SUBJECT: Transmittal of Revised Responses to AP1000 DSER Open Items

AP1000 Design Certification Review  
Draft Safety Evaluation Report Open Item Non-Proprietary Responses

**DSER Open Item Number:** 3.8.2.1-1 Revision 2

**DSER Open Item Number:** 19.1.10.1-5 (Response Revision 2)

Figure A3.5-12

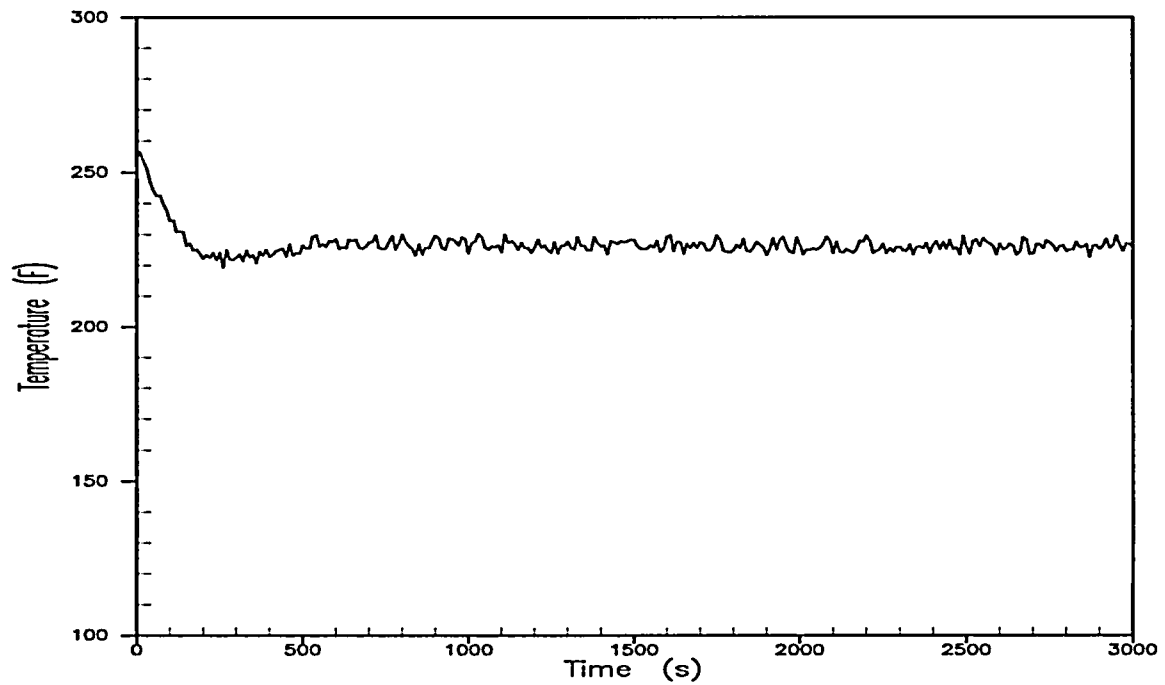
This issue remains open. In the revised response to RAI 720.013, Westinghouse performed long term cooling analyses for bounding conditions in the PRA. (Case F DEDVI, 1 CMT, 1 recirc line, 3/4 ADS4 and CI) and (Case G DEDVI, 1 CMT, 1 recirc line, 4/4 ADS4 and CI failure). The WCOBRA/TRAC code was used for LTC calculations with input conditions derived from MAAP4 analyses. As discussed in the DSER the staff has not reviewed MAAP4 except for its use in screening studies. These are analyses using minimum equipment sets as discussed in the DSER. The staff believes that only a methodology the staff has reviewed should be utilized. In addition, as a result of staff and ACRS questions, the WCOBRA/TRAC long term cooling model has been changed. The staff believes that the revised model should be used in these bounding calculations.

- (a) The long term cooling success criteria analysis case and the thermal hydraulic uncertainty cases F and G have now been performed using the revised WCOBRA/TRAC model and using input conditions from WGOthic. The revised cases replace the previous cases as shown below in the revision to PRA Appendix A.

into the downcomer through the DVI break supplements the IRWST injection. As this flow path becomes established, the levels in the downcomer (Figure A3.5-1), the reactor core (Figure A3.5-2), and the upper plenum (Figure A3.5-8) are sufficient to maintain core cooling. The effect of this injection flow increase is also seen in Figures A3.5-3 and A3.5-4, which show a void fraction decrease in the upper half of the core.

The three available ADS Stage 4 valves provide enough venting capacity that adequate depressurization capability exists to achieve successful performance of the passive safety systems (Figures A3.5-9 and A3.5-10). The fuel remains covered throughout the transient, and adequate core cooling is provided to remove the decay heat. The hot rod cladding temperature at the top of the core is slightly above saturation temperature (Figure A3.5-12) throughout the transient.
